Entergy Operations, Inc.  
1448 S.R. 333  
Russellville, AR 72802  
Tel 479-858-3110

2CAN030706

SUBJECT: License Amendment Request to Support a Partial Re-rack and Revised  
Loading Patterns in the Spent Fuel Pool  
Arkansas Nuclear One, Unit 2 (ANO-2)  
Docket No. 50-368  
License No. NPF-6

**Analysis of Proposed Technical Specification Change**

**Figure 3.9-1**  
**Loading Restrictions for MPC-32**

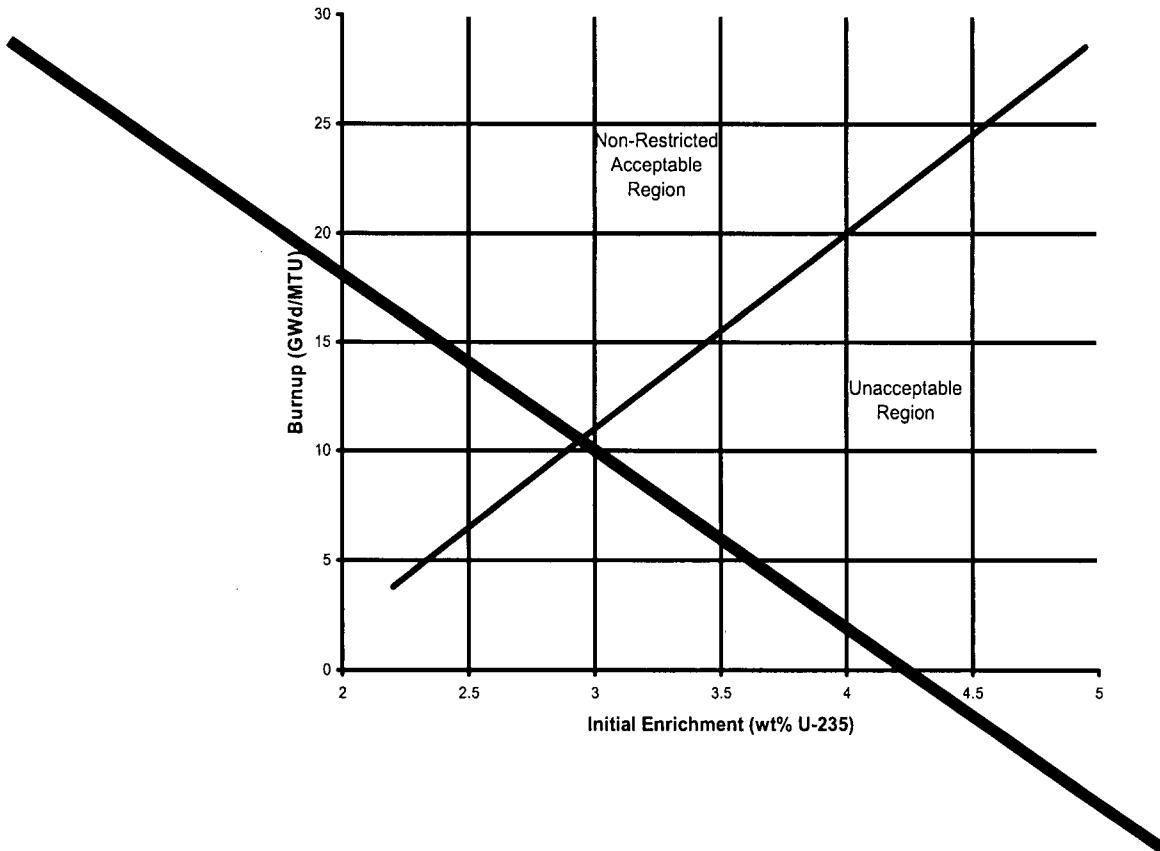
- TS 3.9.12.d, associated Figure 3.9-1, and SR 4.9.12.d will be deleted. This limiting condition for operation and loading restriction was added to support dry cask loading activities. Dry cask loading activities are not governed by 10 CFR 50.68, *Criticality accident requirements*, and therefore are not required to be included in the ANO-2 Technical Specifications that are governed by 10 CFR 50.36, *Technical specifications*.
- Surveillance Requirement 4.9.12.a will be modified to reflect the new fuel assembly U-235 enrichment.
- Surveillance Requirement 4.9.12.b will be changed to reference proposed Table 3.9-1.
- A new SR (proposed SR 4.9.12.d) will be added to direct performance of the coupon sampling program. The coupon sampling program will be added as TS 6.5.17.

Specification 3.9.12.d, associated Figure 3.9-1 and SR 4.9.12.d were added to the ANO-2 TSs to address concerns identified in Regulatory Issue Summary (RIS) 2005-05, *Regulatory Issues Regarding Criticality Analyses for Spent Fuel Pools and Independent Spent Fuel Storage Installations*. The RIS expressed an expectation that a license amendment request be submitted to add a TS to the site's Part 50 license restricting the minimum burnup of fuel assemblies loaded in dry casks in accordance with the criticality analysis guidance contained in 10 CFR 50.68. On January 30, 2007, a new revision to 10 CFR 50.68 became effective. The revision added paragraph (c) which states that the requirements in 10 CFR 50.68(b) do not apply to the fuel located within a dry cask when the dry cask is in the spent fuel pool. Therefore, TS 3.9.12d, SR 4.9.12d, and associated Figure 3.9-1 will be deleted.

Figure 3.9-2

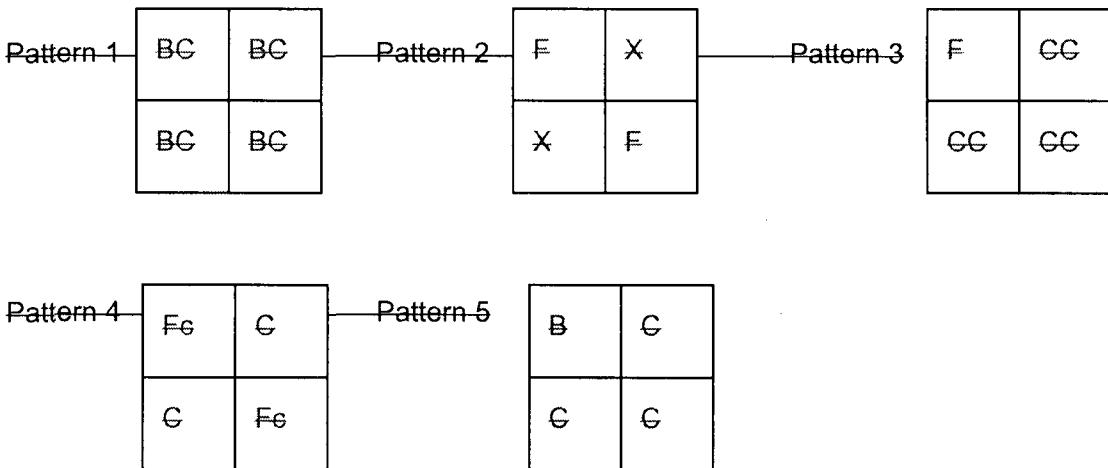
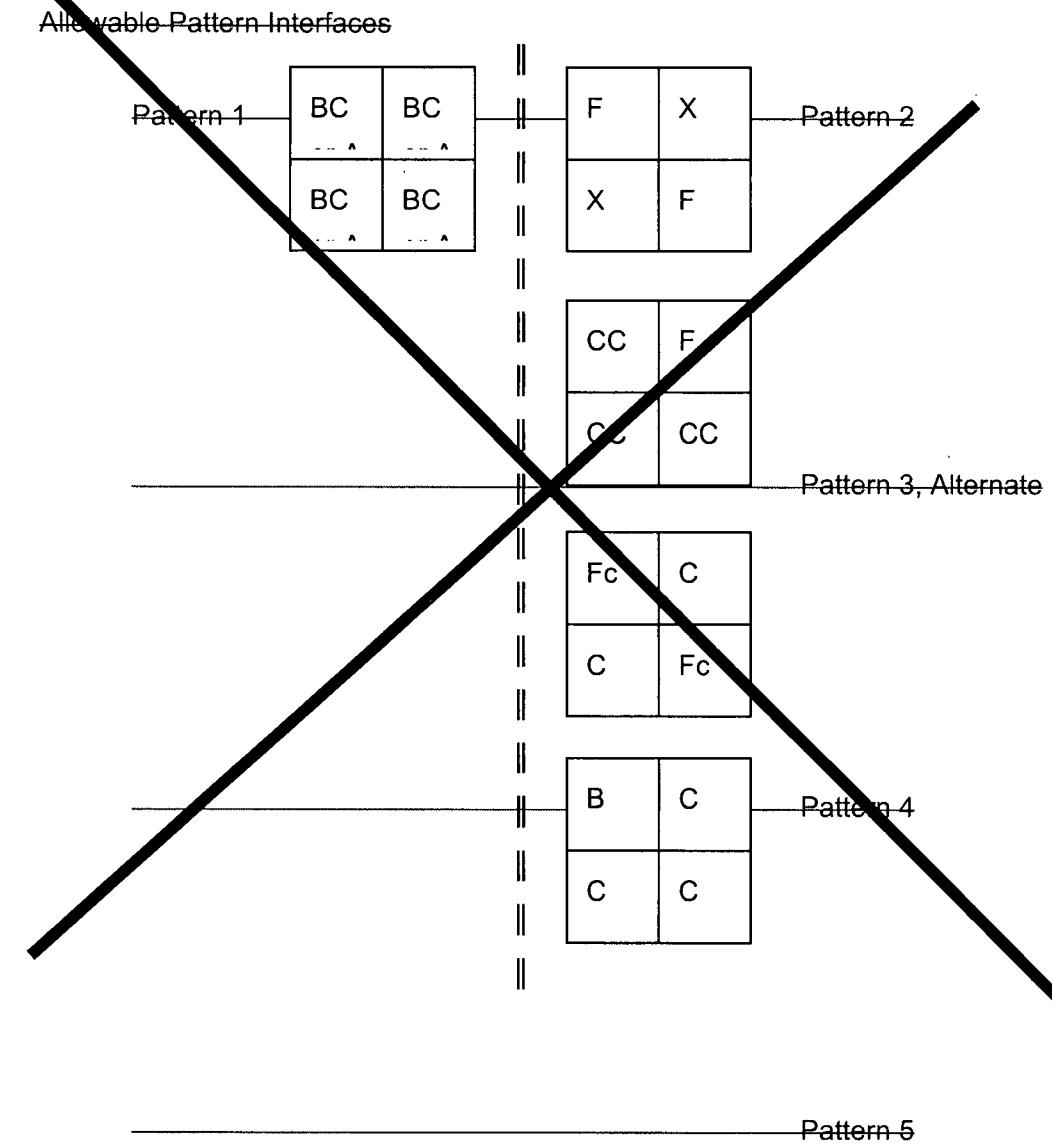
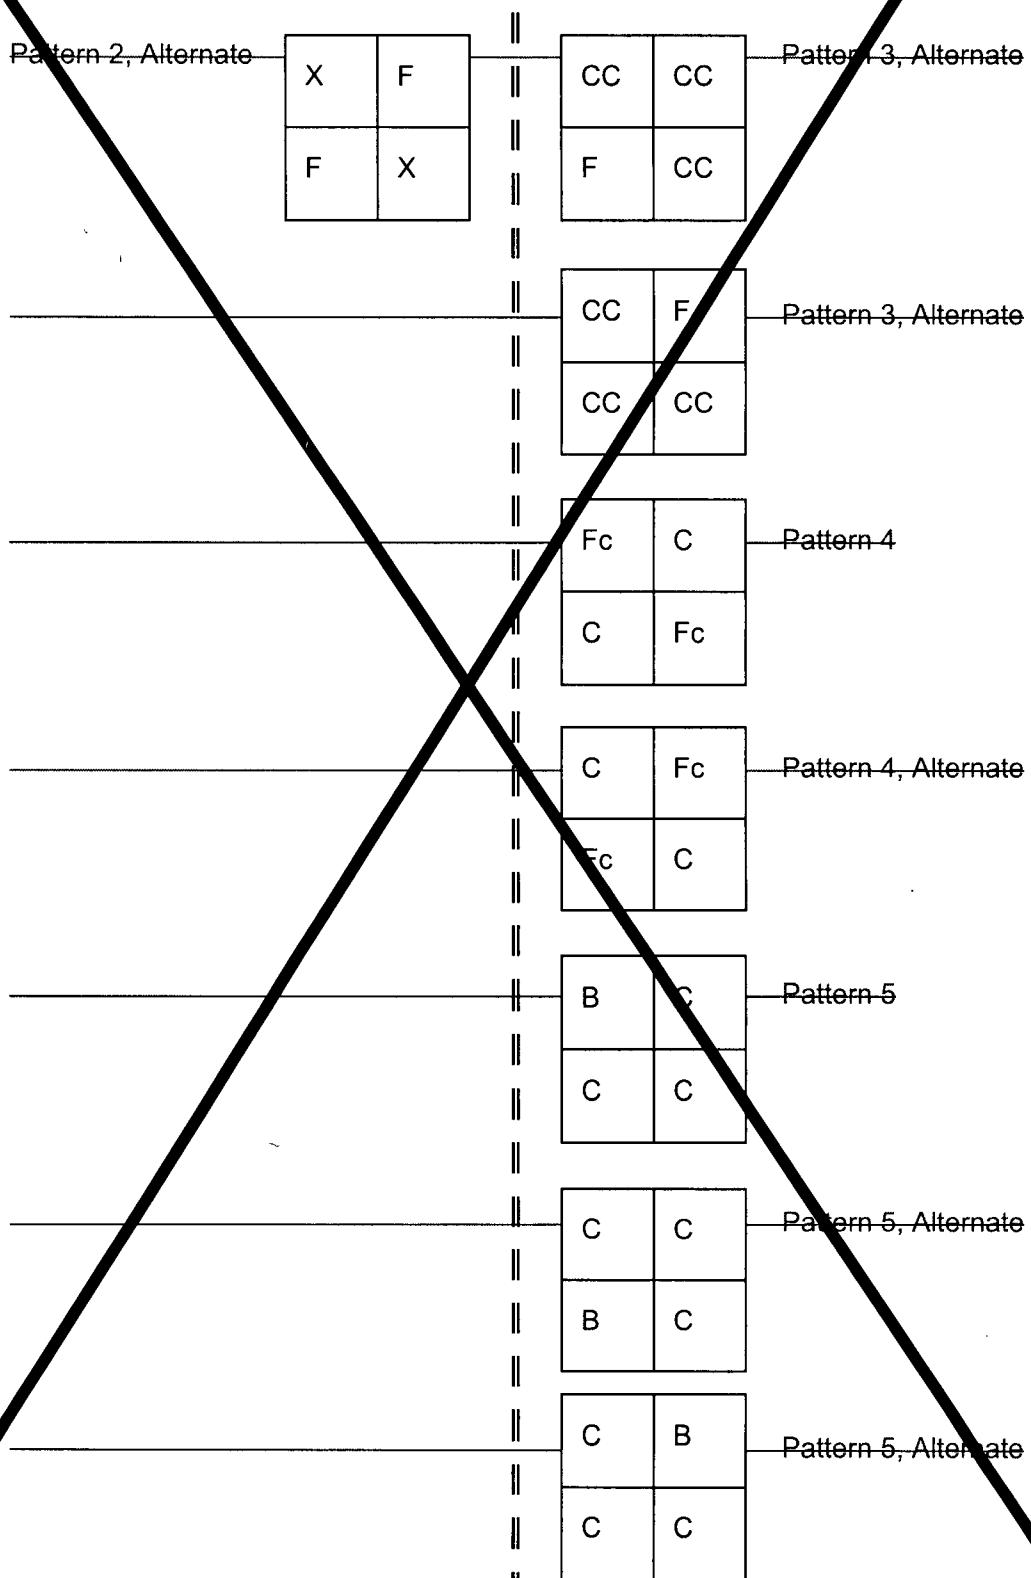
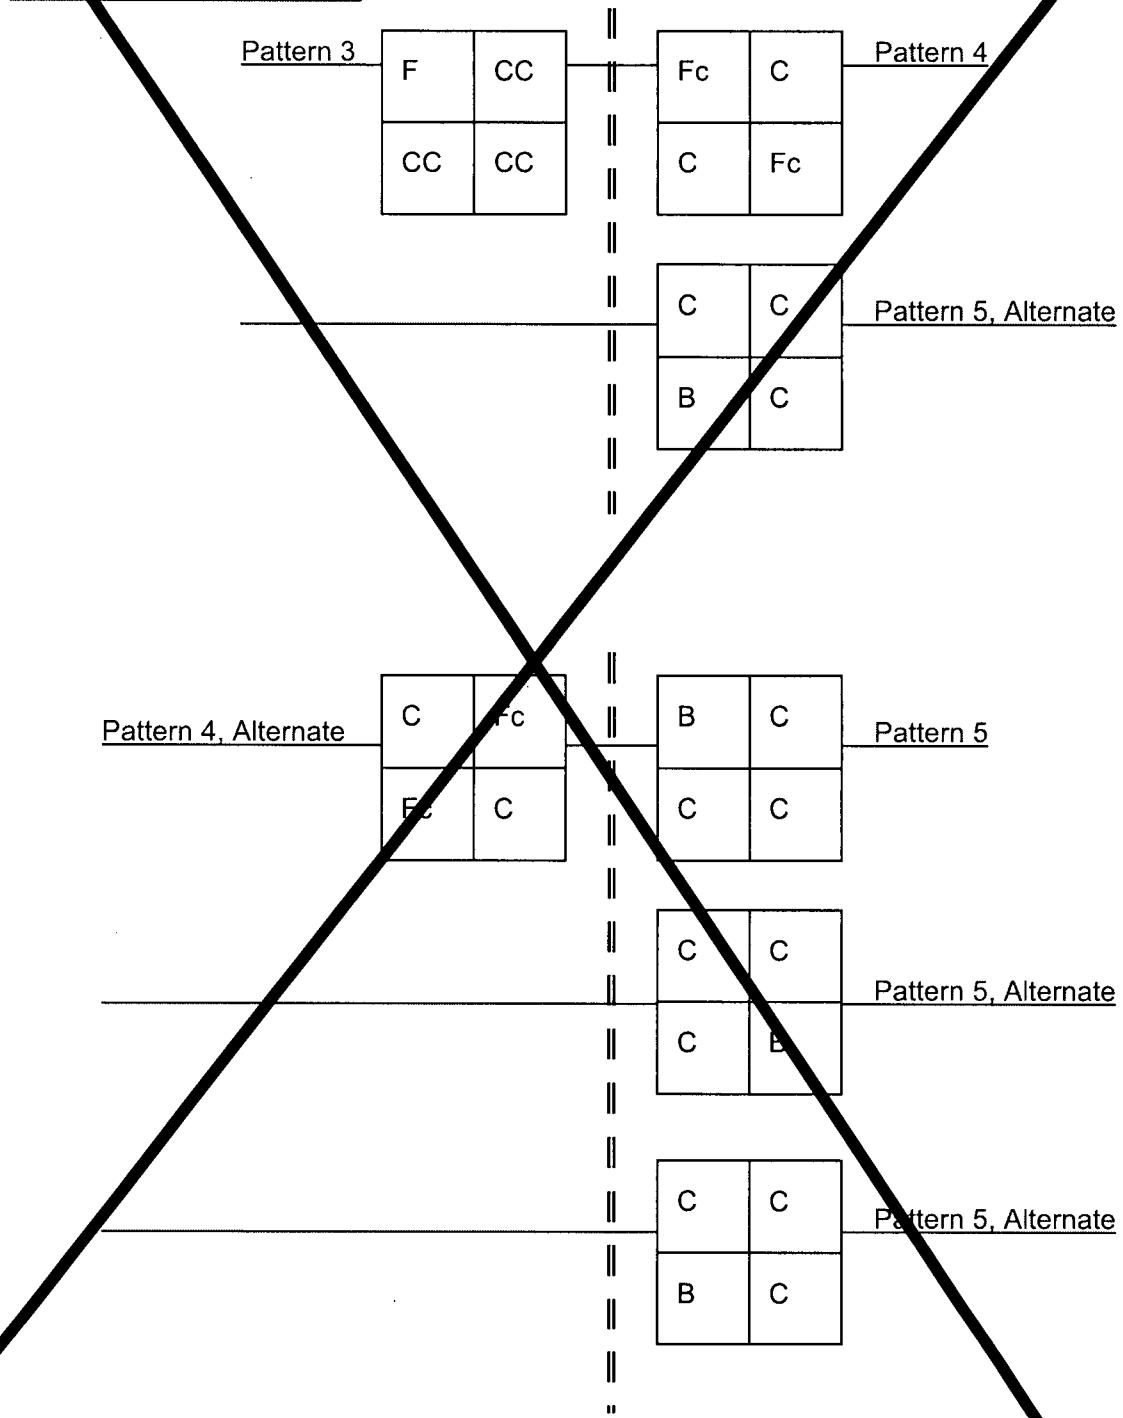
- TS 3.9.12.a, which defines the fuel assembly U-235 enrichment, will be changed to allow storage of fuel assemblies with an initial U-235 enrichment of 4.95 wt%.
- TS 3.9.12.b and Figure 3.9-2 define loading restrictions for fuel assemblies that are stored in the ANO-2 SFP. Figure 3.9-2 will be deleted and revised loading restrictions, which will be reflected in proposed Table 3.9-1, will be added.

Racks must be loaded using one of the five patterns shown in Figure 3.9-2. The type "A" and "C" assemblies have restrictions which are designated in Tables 1, 1-1, 2, and 2-1 of Figure 3.9-2. In any pattern, a less restrictive assembly may be substituted for another assembly within the pattern.

For adjacent patterns, both inside and between racks in the SFP, only the allowed interface configurations shown in Figure 3.9-2 may be used.
